VIPER 990

NEW OPTIONALS
**SHOCKMOUNT
SET FR FLEX**
S990 #903857

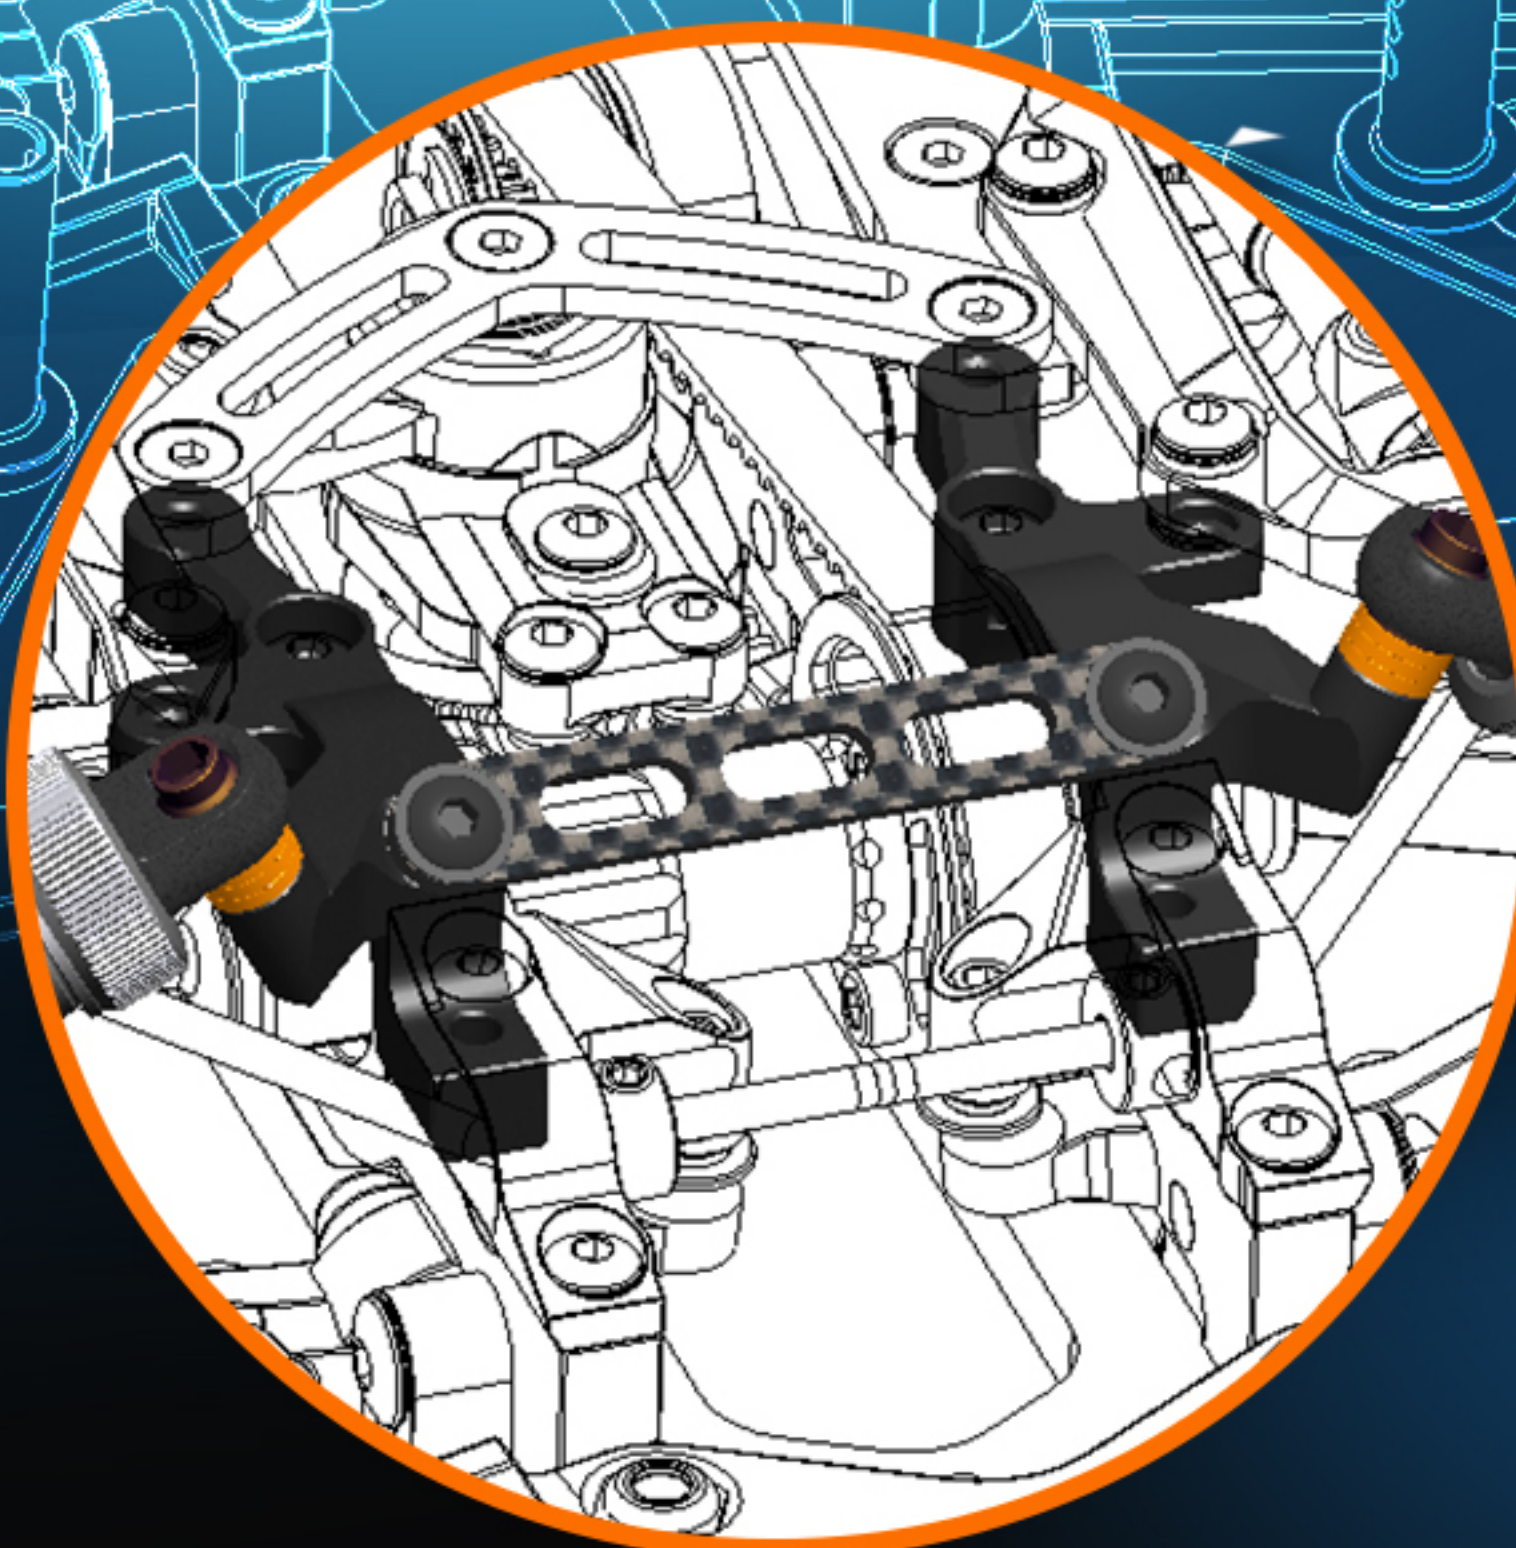
**The new optional
front shockmounts
allow for more flex.**

The traditional shock bracket is replaced by 2 separate mounts. Due to the use of shims, the angle of the shocks can also be adjusted in smaller steps, allowing for an even better suited setup.

The 2 separate mounts can be connected with a bracket to give more stiffness, especially on high traction tracks.
